# Product/Process Change Notification

<b>PCN Number</b>	PCN-00971
<b>Subject</b>	Pin1 Dot Marking Standardization for Legacy Marvell Package Types

<b>PCN Date</b>	11-Jan-2023	<b>Product Type</b>	Integrated Circuit
<b>PCN Type</b>	PCI (Awareness Only)

### Appendix2: Illustration of Pin 1 Marking on Legacy Marvell devices

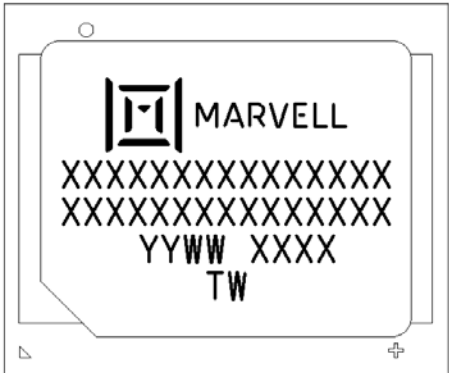
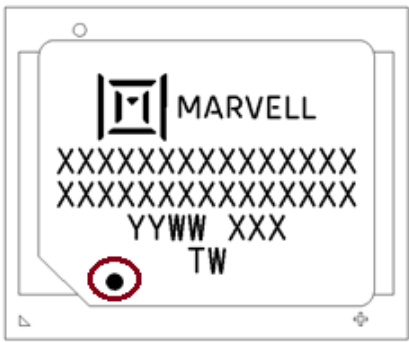
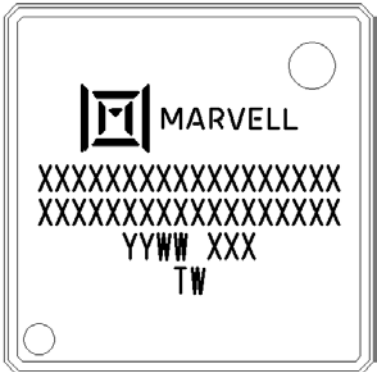
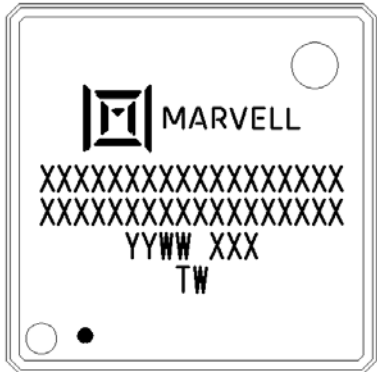
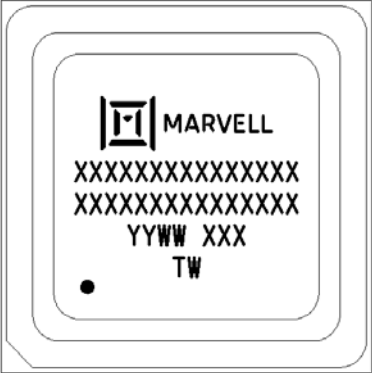
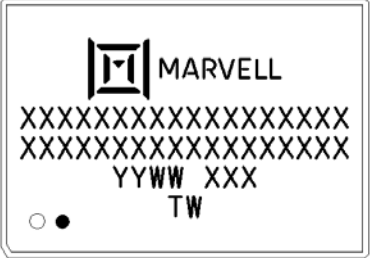
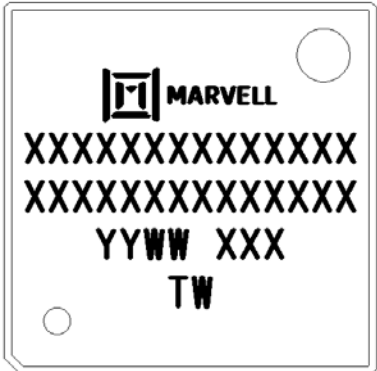
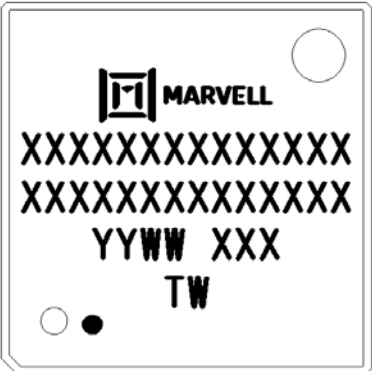
Marvell Part Numbers Affected			
Item Number			
Refer to <b>Appendix1</b>			
Areas Affected			
Assembly Process			
Description of Change			
Marvell plans to add Pin 1 dot marking on package. Refer to <b>Appendix2</b> for the sample illustrations.			
The change will be implemented in production and shipments may have mix of lots with and without Pin1 dot marking until full transition and existing inventory depleted.			
Reason / Benefit of Change			
Standardization of Pin 1 dot marking.			
Anticipated Impact on Form, Fit, Function, Quality or Reliability			
Pin1 dot marking added. No impact on fit, function, quality, and reliability.			
Qualification Status	Complete (*) In Progress	Target Implementation Date	Implementation will be phased in starting in January 2023
Qualification Samples availability		N/A	
Means of distinguishing the change		Pin1 Marking	
Comments

Before	After (with Pin 1 dot on the marking area)
